BP Deepwater Horizon Investigation: Preliminary Insights

Tommy Roth
Vice President, Cementing Product Service Line

John Gisclair
INSITE Support Service Coordinator
September 26, 2010

Key Finding #1

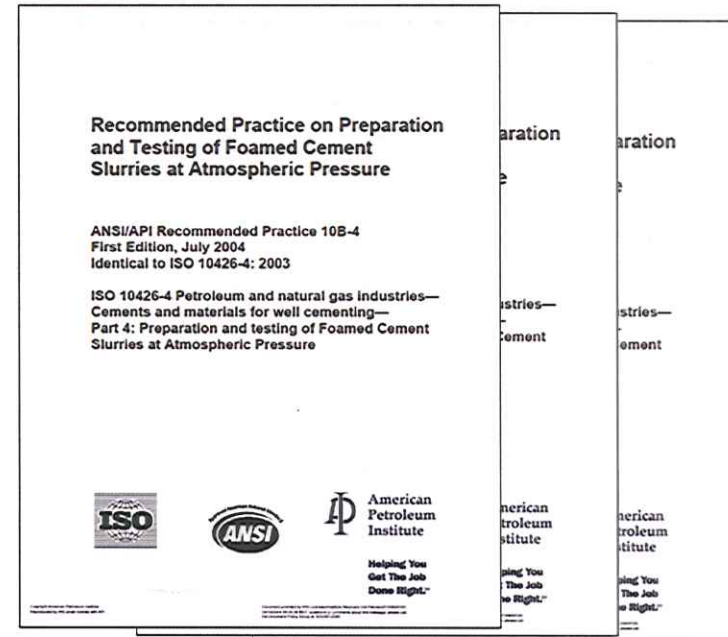
The annulus cement barrier did not isolate the reservoir hydrocarbons

- BP specified top of cement, thereby defining for Halliburton the volume of cement to deliver.
- Stable foam cement slurries are low-fluid loss cements.
- Using rig cement, additives, and rig water, on April 12th, Halliburton tested a stable foam cement slurry using good engineering practices in accordance with ANSI/API standards and procedures.
- The foam cement slurry was executed as designed and quality assured on the rig by a Halliburton engineer (see slide 8).

Modeled with 7 Centralizers

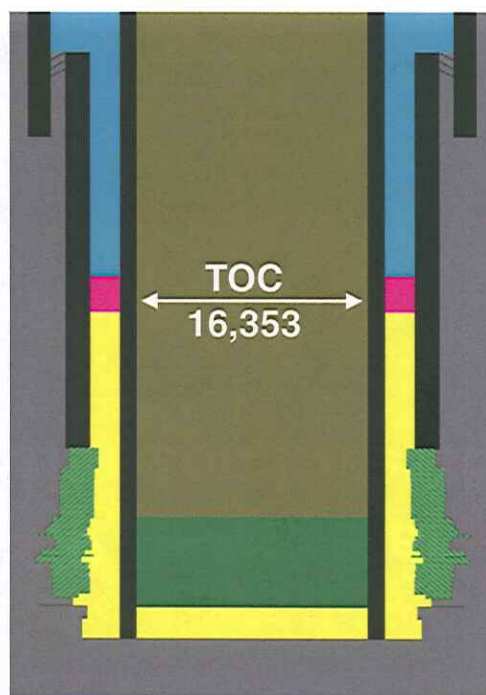
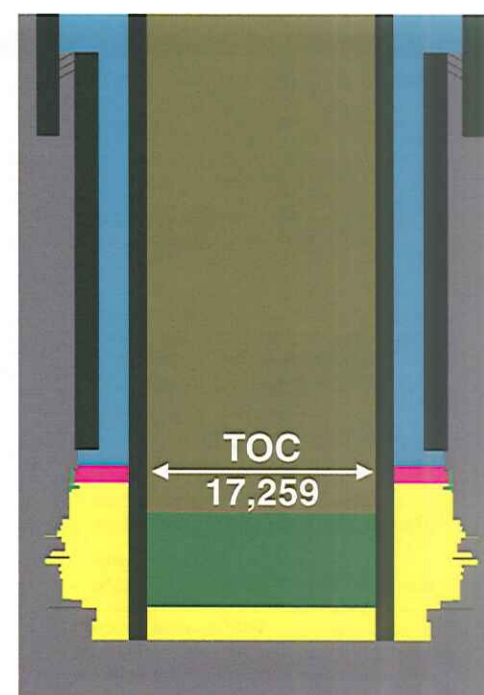
**OptiCem™ modeling
indicated significant
channeling would occur
across the reservoir with
only six centralizers
installed**

- OptiCem™ was also run with 10 Centralizers
- Channeling was still predicted
- OptiCem was run with 21 centralizers
- No channeling was indicated
- Casing was loaded on rig with 6 centralizers
- 15 additional Weatherford centralizers were flown to the rig as specified by BP, but BP chose not to use them

Cement Slurry Design Issues

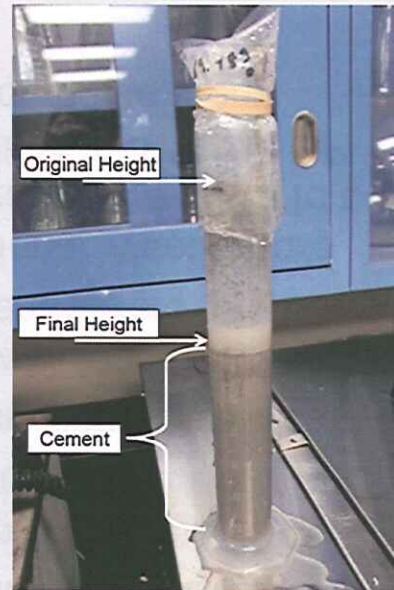
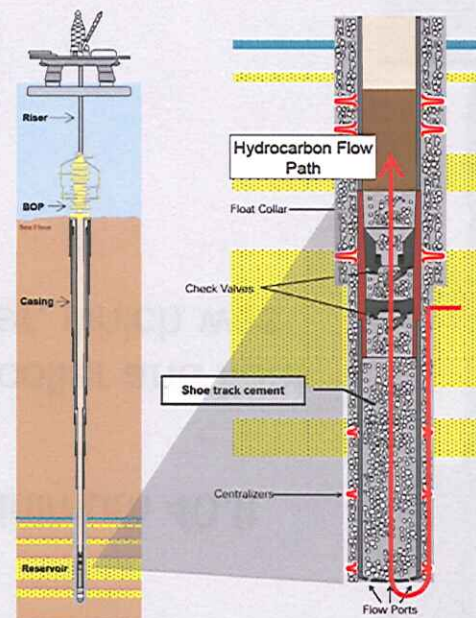
Unstable Foam Sample

An independent lab completed over 500 tests on a representative cement slurry and reported the following:

- 50% quality foam at surface conditions was not stable
- 18.5% quality foam (downhole quality) was not stable
- Yield point of the Halliburton slurry was too low for the foam cement (2 lb / 100 ft² yield point at 135 deg F)
- Fluid loss for the base slurry was excessive compared to industry recommendations (302 cc versus 50 cc per 30 min)

- Using rig cement, additives, and rig water, a stable foam cement slurry was designed and tested using good engineering practices in accordance with API standards and procedures using proprietary chemistry and API 5-blade foam generator.
- In contrast, the CSI lab used substitute cement, additives, and water, which could not replicate the same conditions as the location-sourced material utilized in Halliburton pre-job tests. The CSI lab also used a foam slurry preparation method that did not replicate the foaming apparatus on the rig.
- Halliburton provided cementing services according to BP's well design and direction.

Key Finding #2

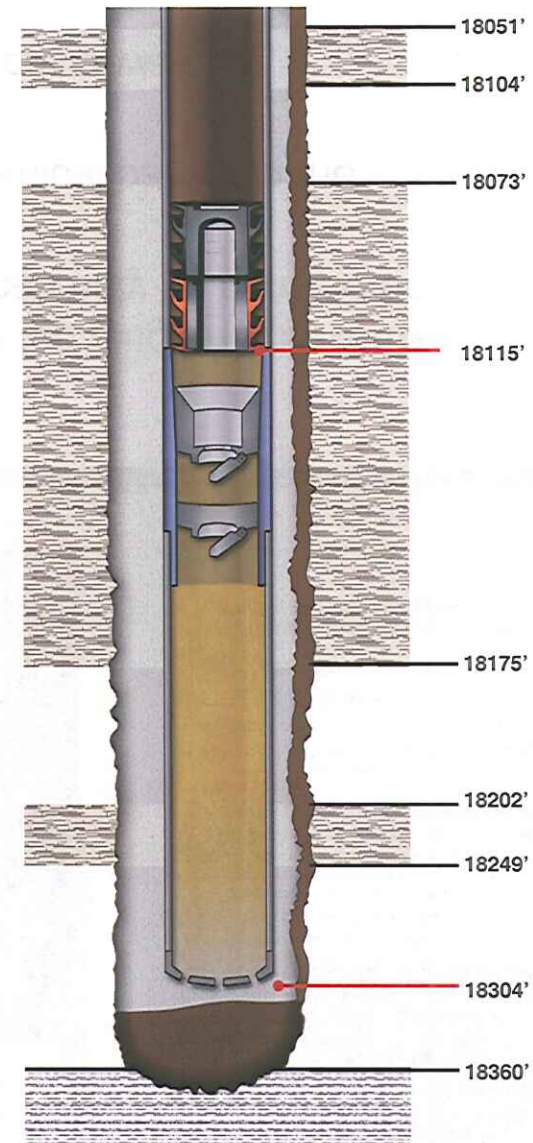
The shoe track mechanical barriers did not isolate the hydrocarbons

Tail cement is displaced down the casing into the shoe track. The tail cement is designed to prevent flow from the annulus into the casing. The float collar valves, which provide a second barrier, must close and seal to prevent flow up the casing.

- Shoe track had two types of mechanical barriers: cement in the shoe track and the double check valves in the float collar
- Shoe track cement failed to act as a barrier due to contamination of the base slurry by break out of nitrogen from the foam slurry
- Hydrocarbon influx was able to bypass the float collar check valves due to either:
 - Valves failed to convert or
 - Valves failed to seal
- Flow through shoe confirmed by fluid modeling and Macondo static kill data

- The shoe track contains contaminated cement ahead of the top plug and prevents it from being pumped into the annulus. Shoe track cement can only be considered a barrier after a successful negative test.
- Conversion of the Weatherford float collar, the single mechanical barrier in the casing, required excessive pressure.
- The integrity of the float collar and casing beneath the float collar was not confirmed.

Apr. 20 – 20:50 to 21:20 (8:50 pm to 9:20 pm)

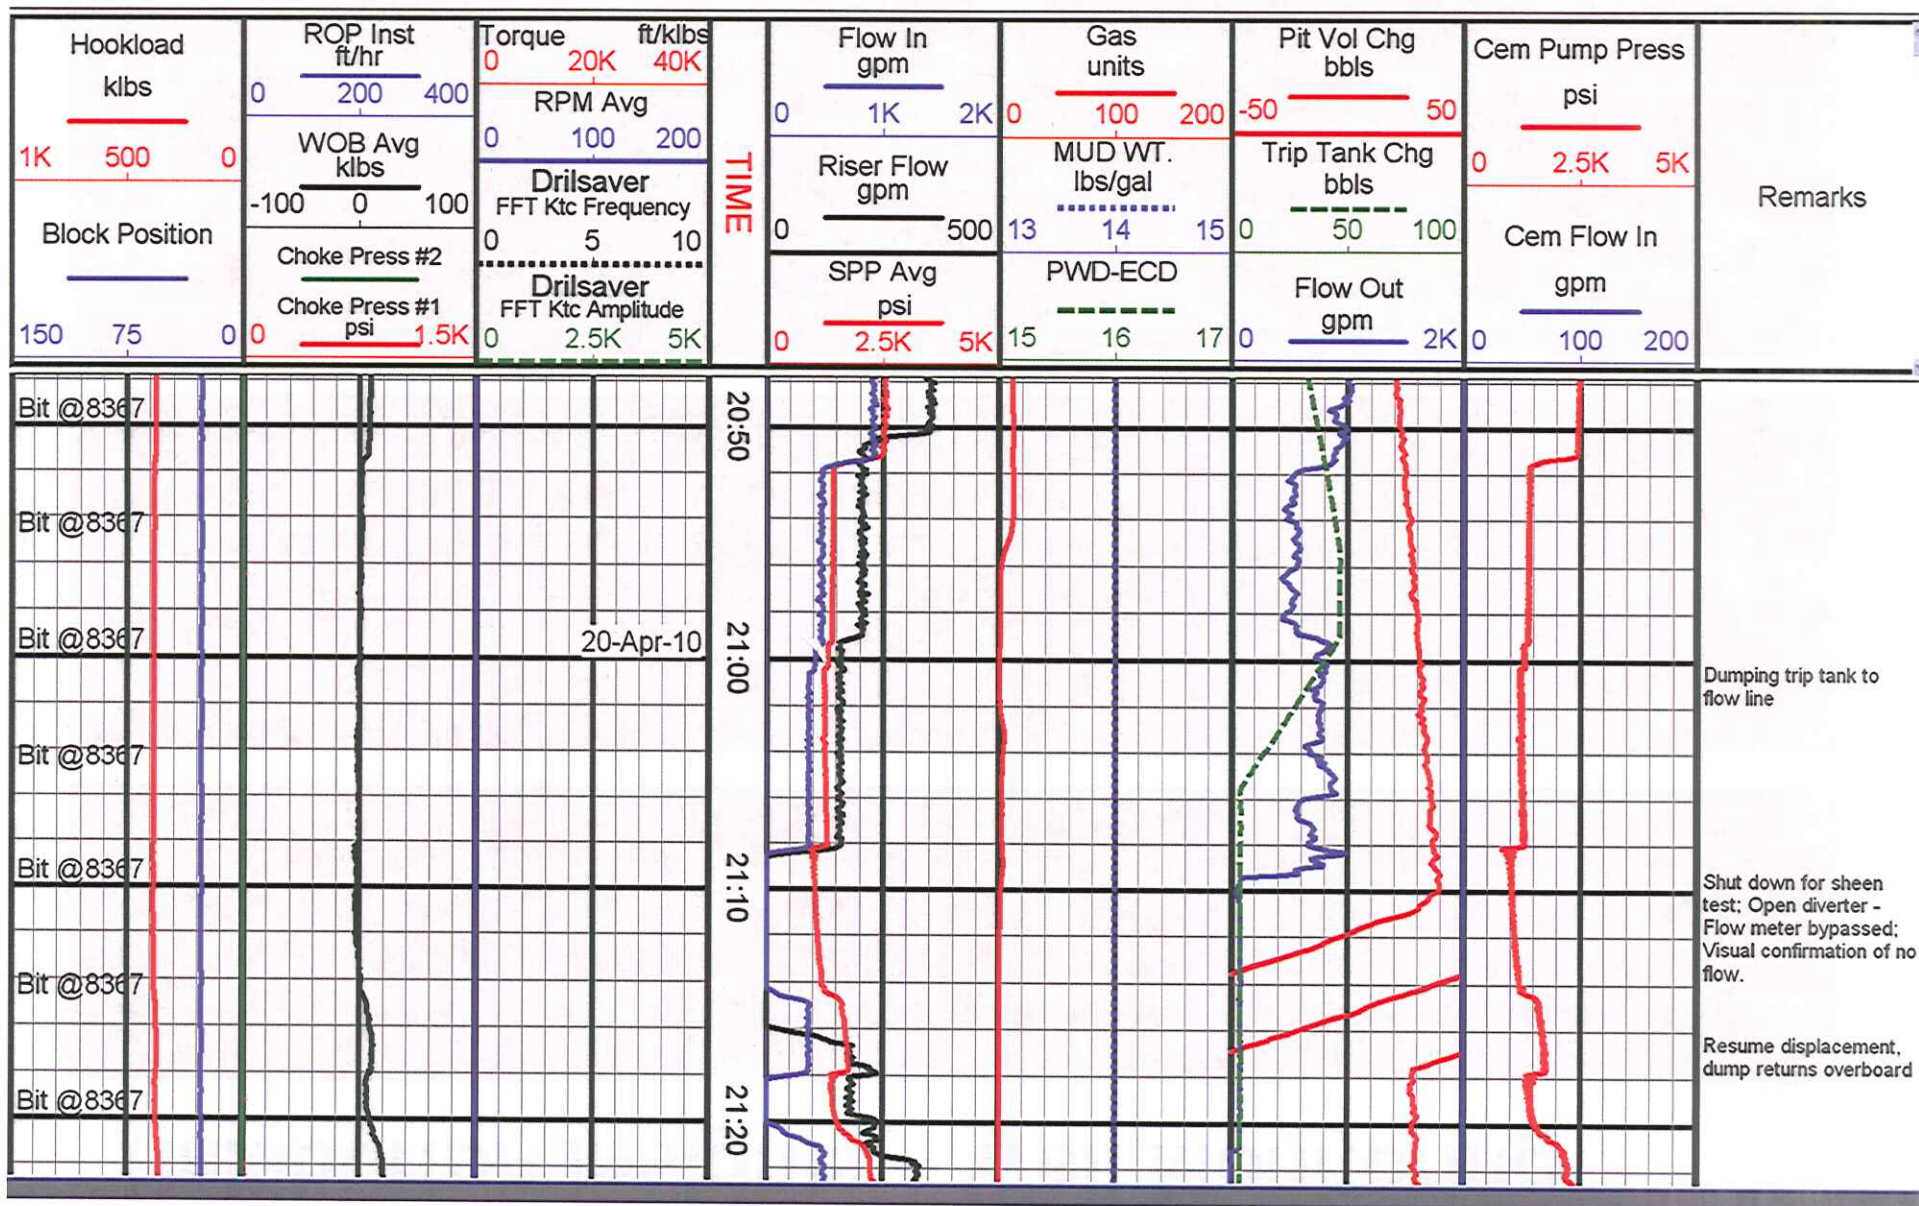
Effective rig monitoring relies on an accurate rig activity log to interpret the data responses. If multiple rig activities affect the same data (e.g., transferring mud and taking returns to the same pit), it becomes difficult to evaluate in real time how severely each activity affects the data.

Rig activities that precluded well monitoring

- Flow diverted overboard, which bypassed pit level and gas sensors
- Crane and ballast operations influenced flow out sensor readings
- Mud displacement using unmonitored source pit (sea water chest)
- Tank draining added flow to return line and pits (trip tank, sand trap)
- Fluid was being transferred between pits

Rig activities unknown to mud loggers

- When the rig stopped transferring mud to the supply boat
- Returns switched from active to auxiliary pits
- Transfers of fluid between pits
